November 18, 1998

United States Department of the Interior
CALIFORNIA DEPARTMENT OF PARKS AND RECREATION
Redwood National and State Parks
1125 16th Street
Arcata, California 95521

Thank you for the opportunity to comment on the proposed Total Maximum Daily Load (TMDL) for Redwood Creek. Redwood National and State Parks (RNSP) is situated at the downstream end of Redwood Creek and encompasses about 40 percent of the entire Redwood Creek basin. The resources found in RNSP are public trust resources of national and international significance. Because of the park's downstream location, park resources are vulnerable to sedimentation originating from areas upstream of the park.

Figure 1. 10-year Rolling Averages, Orick vs O'Kane

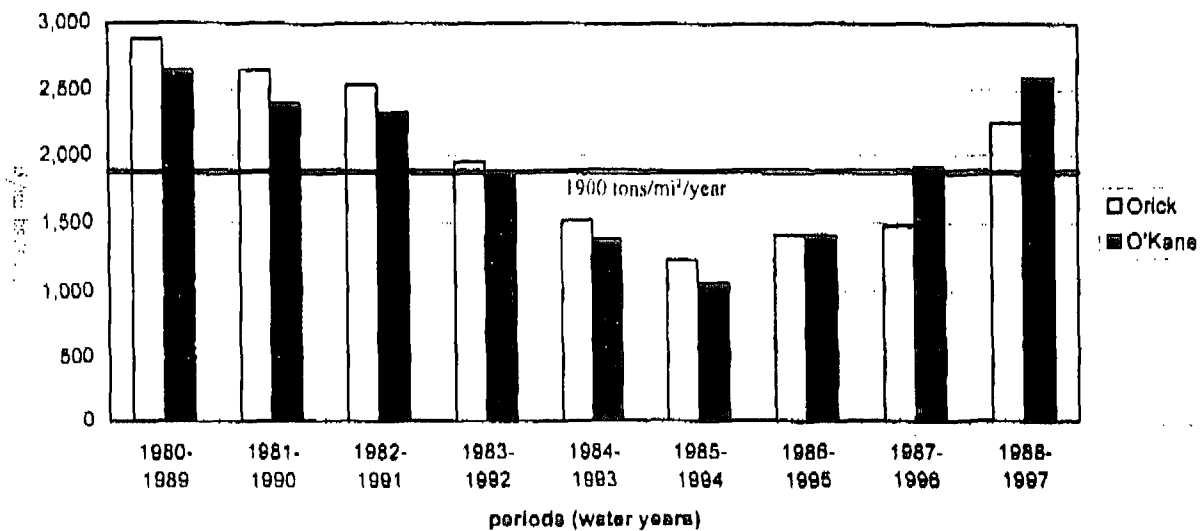
To see how reasonable the TMDL might be, it was compared to recent events by plotting the 10-year rolling averages for Redwood Creek from 1980 to 1997 (Figure 1). The years between 1980 and 1995 were marked by low to moderate rainfall with the largest storm having a 5-year recurrence interval. During this period, total sediment loads (suspended and bedload) at the Orick station were consistently higher than at O'Kane (as expected because of Orick's larger drainage area) and the 10-year rolling averages eventually fell below the TMDL threshold. This period coincided with recovery trends for the main channel of Redwood Creek, when it was flushing stored sediment from its channel. Since 1995, with the onset of higher rainfall, this trend has reversed. Sediment loads at both stations increased above threshold limits, and the O'Kane station began recording higher sediment loads than the station at Orick. Despite its relatively low (3-year return interval) rainfall intensity, the January 1, 1997 storm was the largest (11-year) flood since 1975. Significant erosion occurred from roads and cutover streamside areas in many parts of the basin, especially in areas upstream from the O'Kane station. The TMDL sediment threshold was exceeded during these winter storms, indicating the TMDL for Redwood Creek is probably a reasonable threshold for land management practices in the Redwood Creek basin.
